UNITED STATES  
NUCLEAR REGULATORY COMMISSION  
WASHINGTON, D. C. 20555

RE: OCONEE NUCLEAR STATION, UNITS 1, 2 AND 3

SAFETY EVALUATION AND STATEMENT OF STAFF POSITIONS  
RELATIVE TO THE EMERGENCY POWER SYSTEMS  
FOR OPERATING REACTORS

Response to NRC Staff Position on Degraded System Conditions

Oconee Nuclear Station  
Preliminary Logic Diagram  
230KV Switchyard Degraded Voltage Protection  
NSM ON-52850  
May 4, 1990

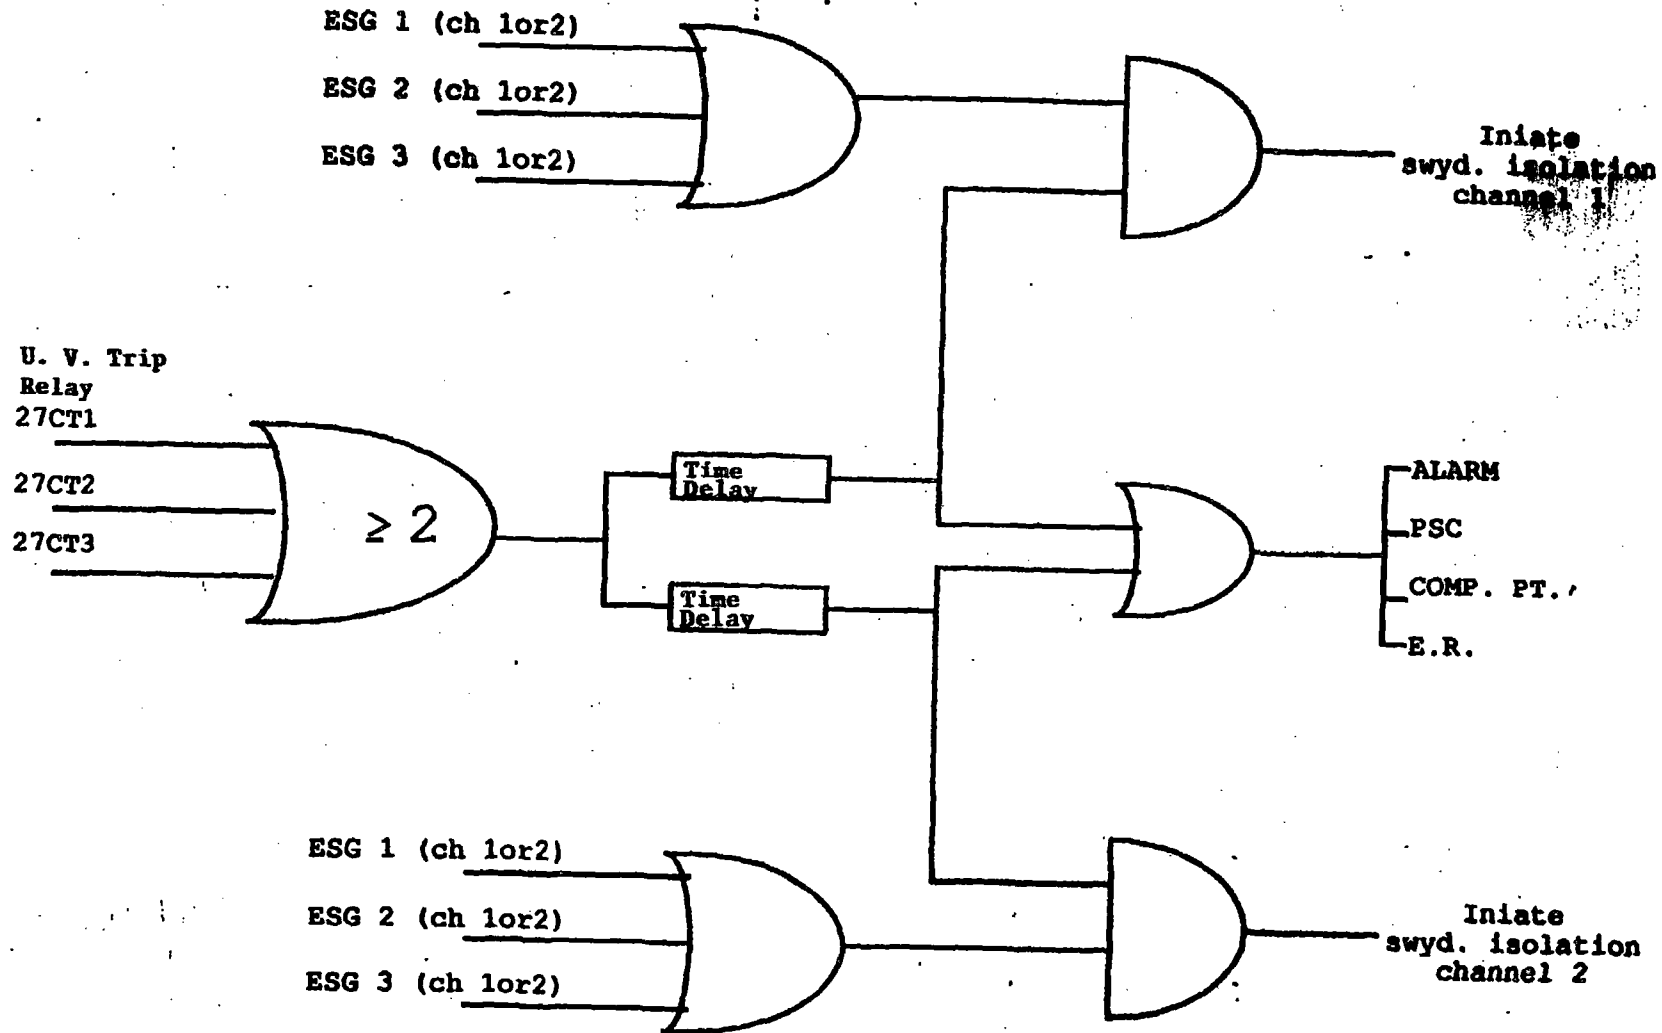
In a letter dated May 8, 1990, the licensee provided a conceptual description of the permanent hardware modification intended to eliminate the design deficiencies. New undervoltage relays with setpoints of 222.5kV will be installed utilizing existing potential transformers in one phase on the primary side of each unit's startup transformer. Two-out-of-three logic will be used to generate an undervoltage signal. After a 9 second time delay this signal will then generate alarms in the control rooms and, if an ES signal from any unit's Engineered Safeguards Protective System exists, will then isolate the 230 kV switchyard from the offsite 230 kV electrical grid.

The design modification has only the 9 second fixed delay. A second, longer time delay has not been incorporated into the design. Also, the undervoltage condition in itself does not result in the separation of the Class 1E distribution system from the offsite grid; an ES (LOCA, MSLB) signal must exist coincidentally before undervoltage protective action occurs.

In response to a staff question, the licensee stated, in a phone conference call, that after a degraded grid alarm is received, steps will be taken to re-establish an adequate voltage level on the grid. For a sustained degraded grid condition, analyses (see licensee's letter dated June 18, 1990) related to LERs 269/90-04 and 269/90-05 have been performed covering equipment and plant performance down to the worst setpoint (203 kV) of the existing degraded grid protection circuitry. This circuitry will remain installed and will provide automatic separation from the grid for scenarios without an ES signal and where voltages drop to levels near where equipment/plant performance is unanalyzed.

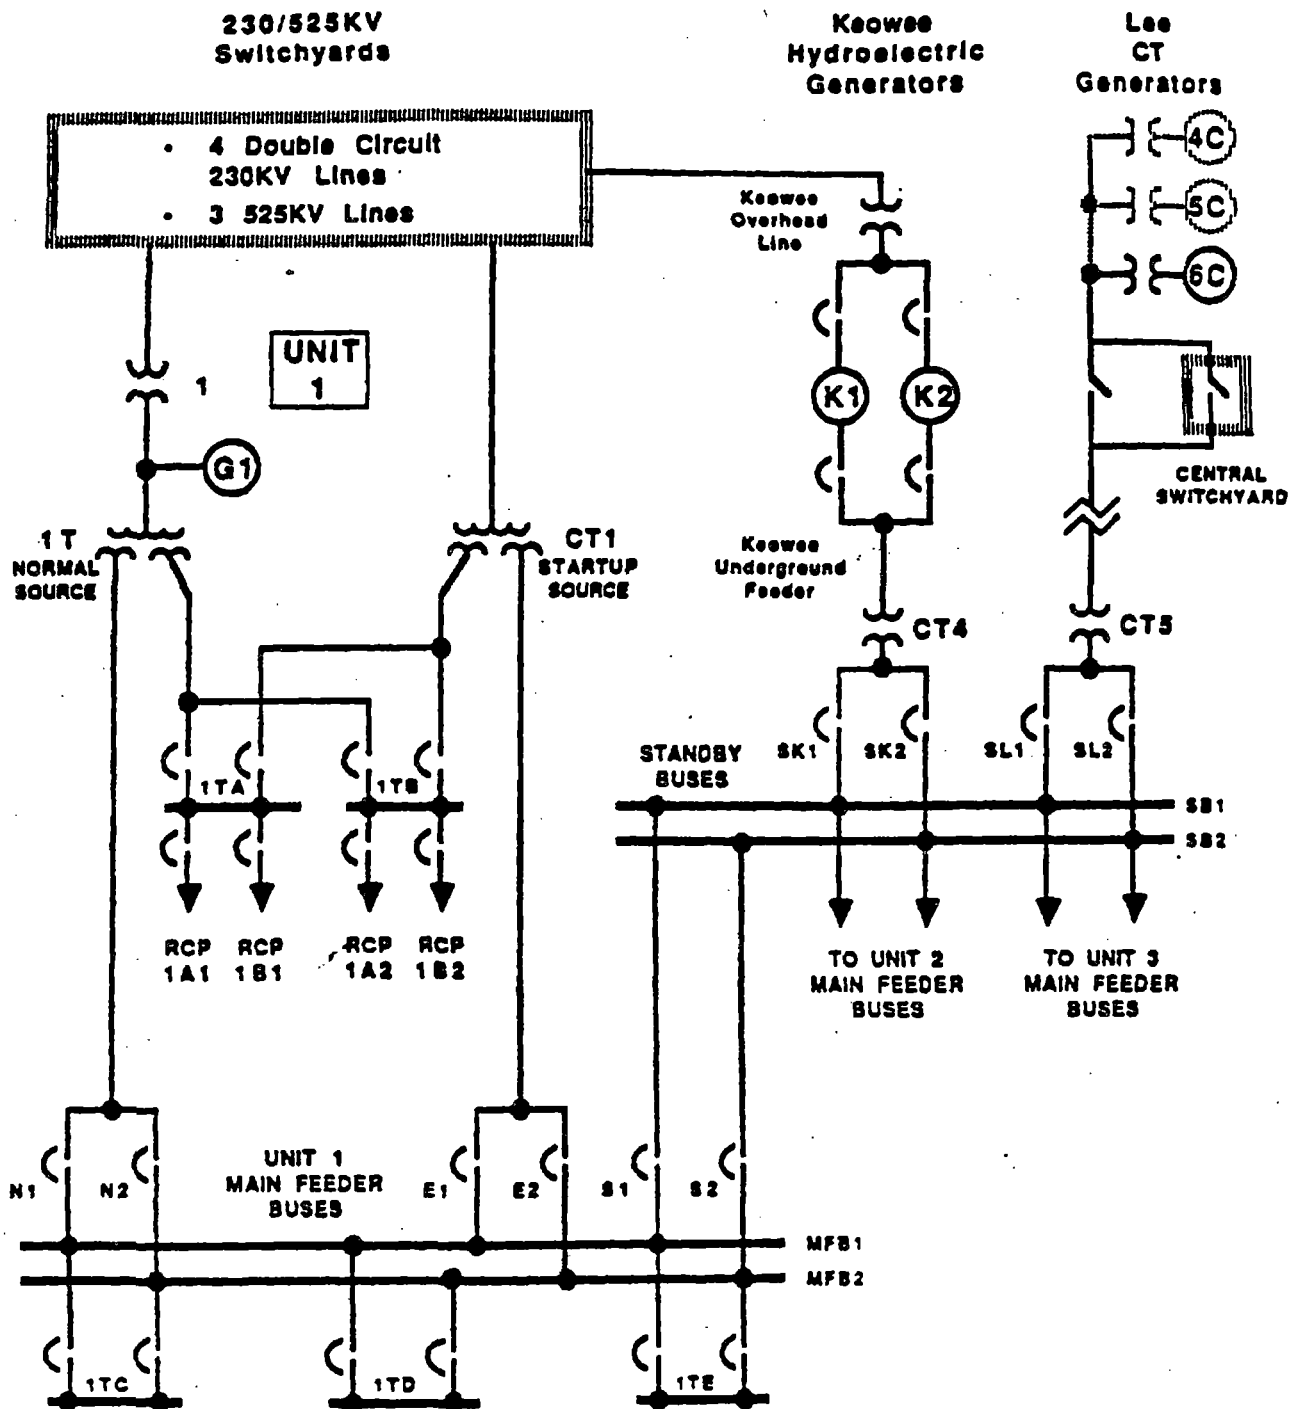
8. Bypass annunciation shall be provided in the control room. The staff's review of the proposed design modification indicates that bypasses are not used in the design.
9. Technical specifications shall include limiting conditions for operation, surveillance requirements, and trip setpoints and allowable values for undervoltage relays and time delay devices.

In response to a staff question, the licensee stated that technical specifications will be proposed but setpoints and time delays will not be specifically identified.
